GE Appliances

# Service Bulletin

TCX18 BOTTOM MOUNT  
FREEZER STEP SHELF KIT

REF 02-00

**FINAL ASSEMBLY OF STEP SHELF KIT**  
(Icemaker not installed in picture)

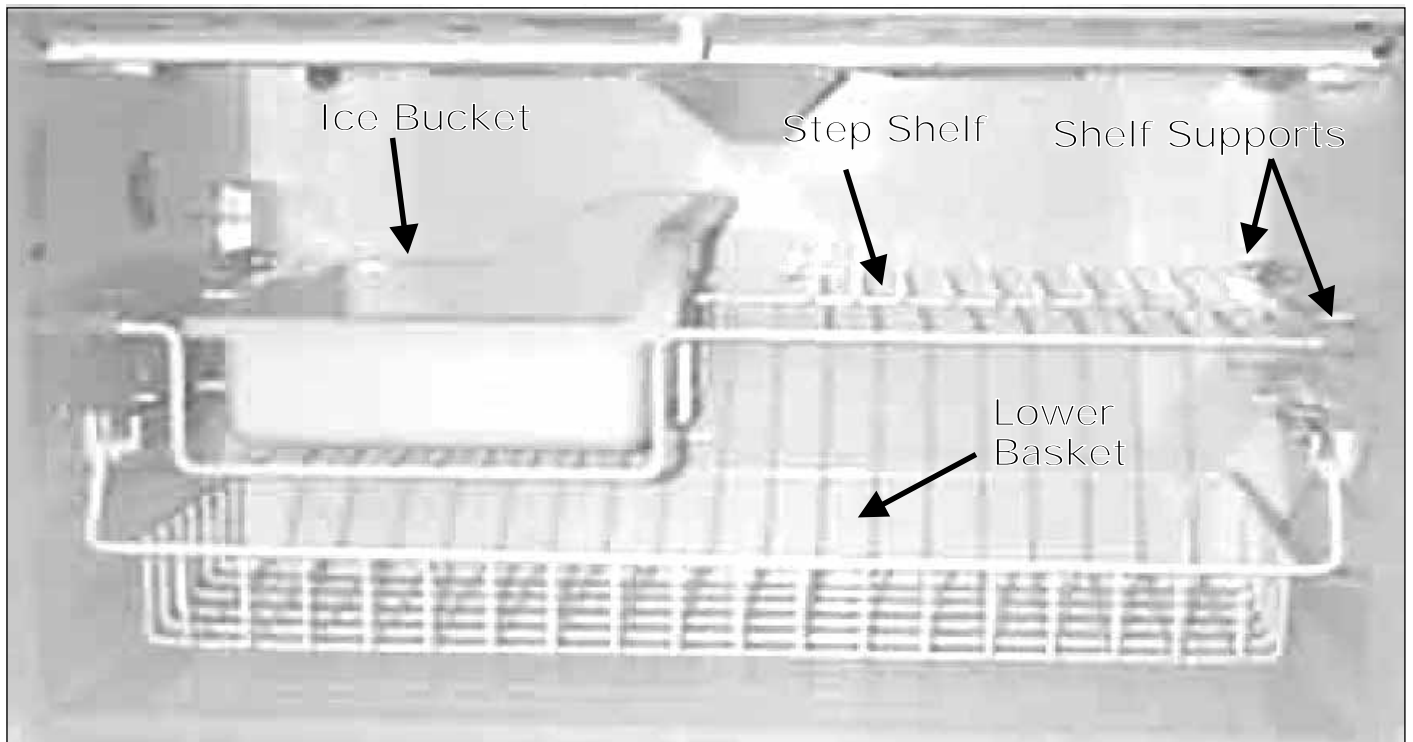
The **TCX18PAC/TCX18IAC** freezer basket assembly was **redesigned to eliminate ice cubes missing the bucket and ice overflow problems** currently seen in the field on these models with IM3 icemakers.

The redesign eliminates the small upper basket and adds a fixed shelf across the top with a step on the left-hand side to accommodate a larger ice bucket. The lower sliding basket was changed slightly to allow for the step shelf. The new design eliminates the inverted ice tray shelf and extension arm previously required for the icemaker assembly.

The parts required to convert the old model to this new model can be ordered as a kit, part number **WR49X10020**. The kit contains 1 lower basket, 1 step shelf, 1 ice bucket, 4 shelf supports and a set of installation instructions.

**NOTE: A service technician must install this kit.**
